Title - Sujet Restauration de la Place George V Restauration de la Place George V, Québec (Québec)	
Solicitation No. - N° de l'invitation EE520-222036/A	Amendment No. - N° modif. 004
Client Reference No. - N° de référence du client R.094682.101	Date 2022-03-08
GETS Reference No. - N° de référence de SEAG PW-\$QCM-009-18288	
File No. - N° de dossier QCM-1-44166 (009)	CCC No./N° CCC - FMS No./N° VME
Solicitation Closes - L'invitation prend fin at - à 02:00 PM Eastern Daylight Saving Time EDT on - le 2022-03-22 Heure Avancée de l'Est HAE	
F.O.B. - F.A.B. Plant-Usine: <input type="checkbox"/> Destination: <input checked="" type="checkbox"/> Other-Autre: <input type="checkbox"/>	
Address Enquiries to: - Adresser toutes questions à: Thellend, François	Buyer Id - Id de l'acheteur qcm009
Telephone No. - N° de téléphone (418) 905-1853 ()	FAX No. - N° de FAX () -
Destination - of Goods, Services, and Construction: Destination - des biens, services et construction:

RESTORATION OF PLACE GEORGE V, QUEBEC CITY (QUEBEC)

AMENDMENT 004

The objective of solicitation amendment 004 is to provide bidders with questions and answers 014 to 028 and to issue Addendum S-01 available for download on the s

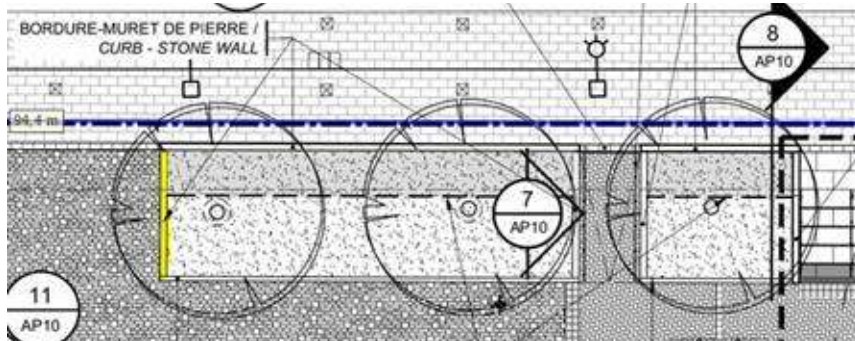
Is the section identified in yellow on the plan a wall curbstone or Type 1 curb?

This curbstone section drawing is type 1 and not a wall curbstone. A correction will be made to the construction drawings.
